**STATE SIGNIFICANT DEVELOPMENT
ASSESSMENT REPORT:
*Forensic Pathology and Coroner's Court,
Lidcombe*
(SSD 7545)**

Environmental Assessment Report
Section 89H of the *Environmental Planning and
Assessment Act 1979*

March 2017

Figure 9: Proposed access arrangements from Main Avenue, RtS (source: RtS)

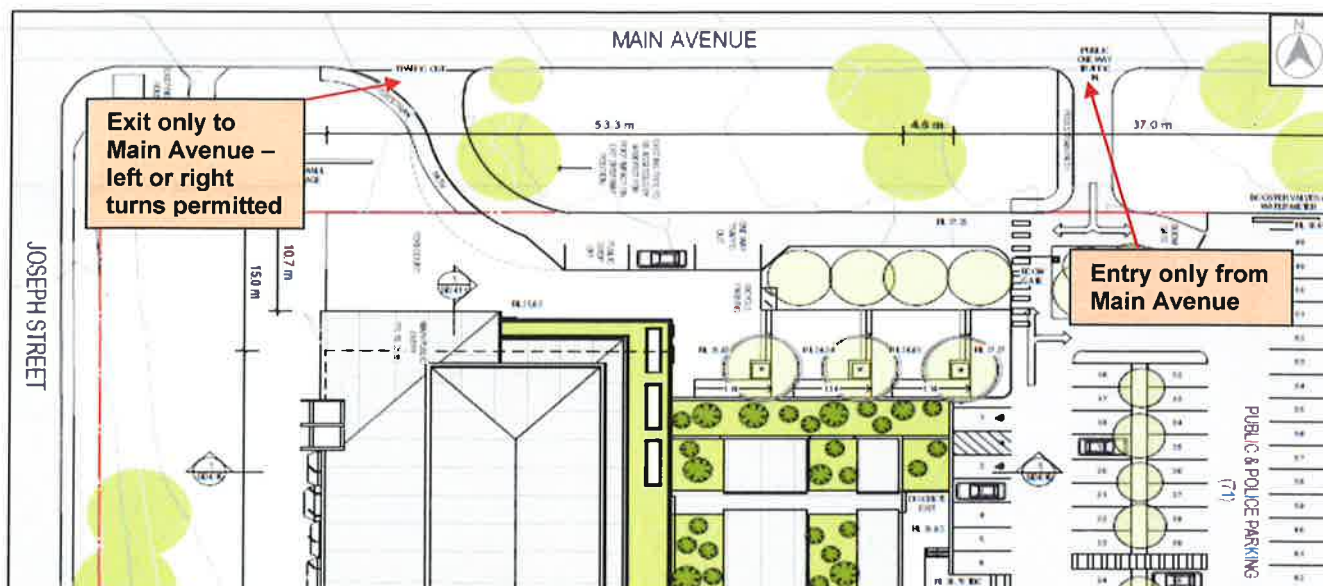
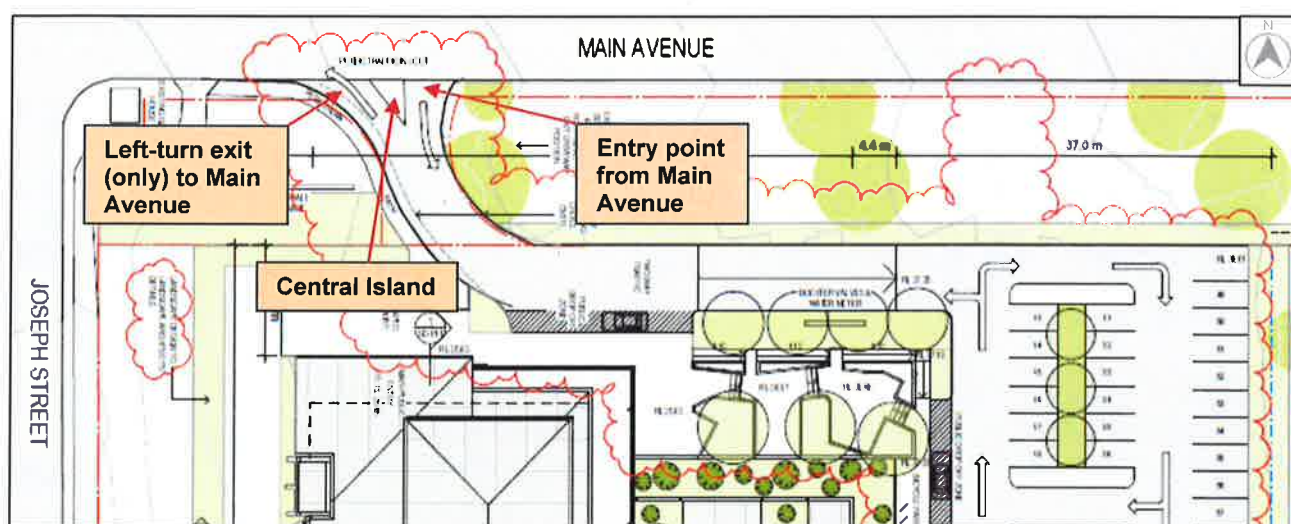
In response to the issues raised during exhibition, the Applicant submitted revised project plans which included amendments to the public vehicle access arrangement. The amendment includes removal of the eastern entry/exit driveway and establishment of a central island over a short section of Main Avenue. The central island will prevent vehicles from turning right when exiting the site, consequently directing vehicles to Joseph Street (via Main Avenue) rather than Botanica Drive.

Figure 8 and **Figure 9** are plans submitted with the EIS and RtS, respectively, which shows the amendments made to the project in response to the traffic issues raised by the Department and the general public.

The Department considers the revised access arrangement submitted with the RtS appropriately responds to the concerns raised in submissions on the potential increase in traffic along Botanica Drive. The proposed arrangements to force left-turn movements only into Main Avenue channels all vehicles towards Joseph Street when departing the site. To ensure this measure is implemented, the Department has recommended a condition that requires the provision of appropriate physical measures, such as a central island, that would prohibit vehicles exiting the public car park from turning right into Main Avenue.

Figure 11: Construction traffic routes to and from the site (source: EIS)

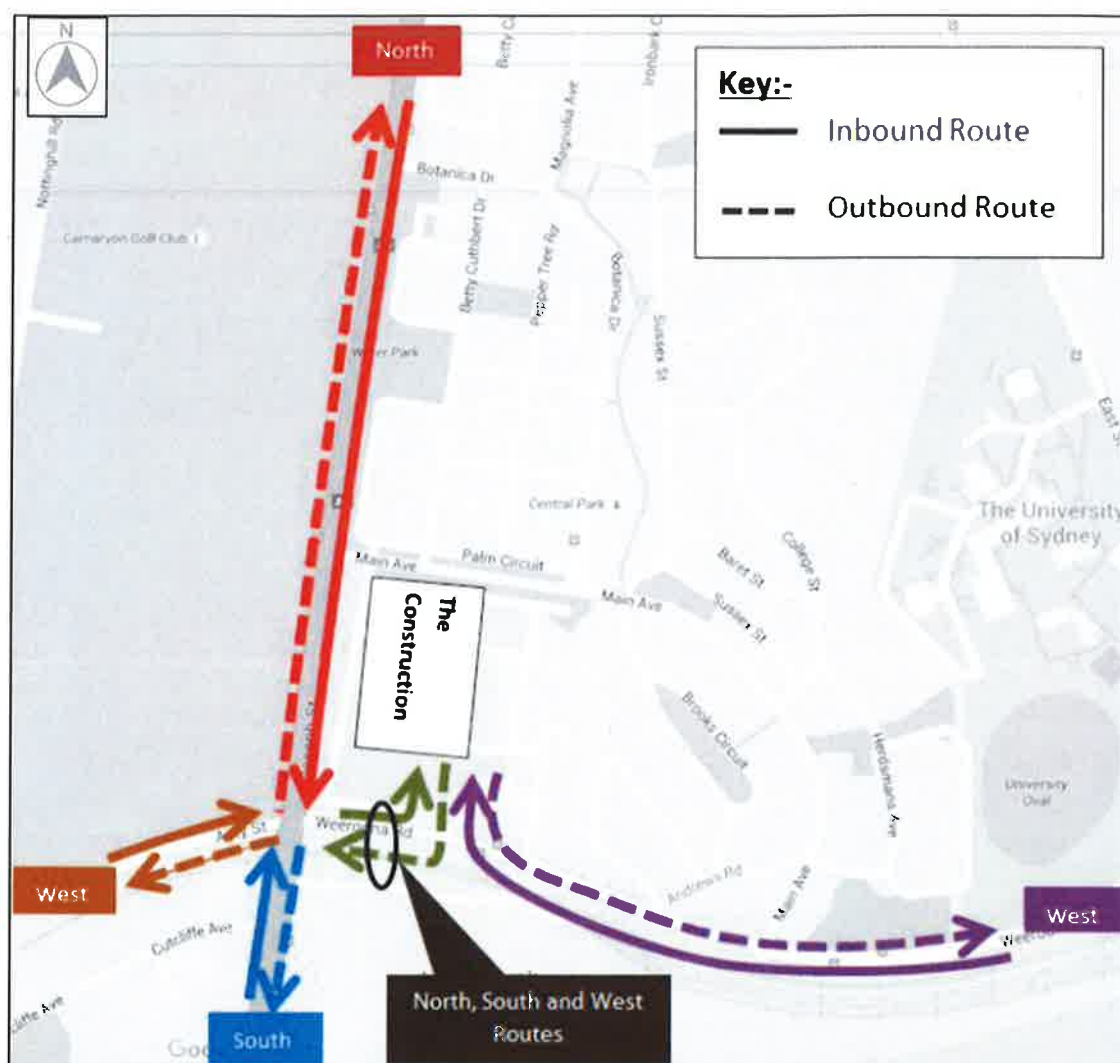
TfNSW recommended in its submission on the EIS that the Applicant prepare a final Construction Traffic Management Plan, which is to outline potential impacts and management measures to existing traffic flows, pedestrians, cyclists and bus services (including the M92 route which travels along Weeroona Road).

The Department considers construction traffic impacts across the broader road network as a result of the development can be managed as part of a final Construction Traffic and Access Management Plan (CTPMP), recommended via condition to be prepared prior to the commencement of construction and to the satisfaction of the Certifying Authority. The CTPMP is required to:

- be prepared by a suitably qualified expert and in consultation with Council and TfNSW;
- confirm details of predicted traffic volumes, types and routes;
- identify potential impacts to traffic, pedestrian access, cyclists routes and bus services including the M92 bus route along Weeroona Road; and
- provide suitable pedestrian and traffic management measures throughout the period of construction.
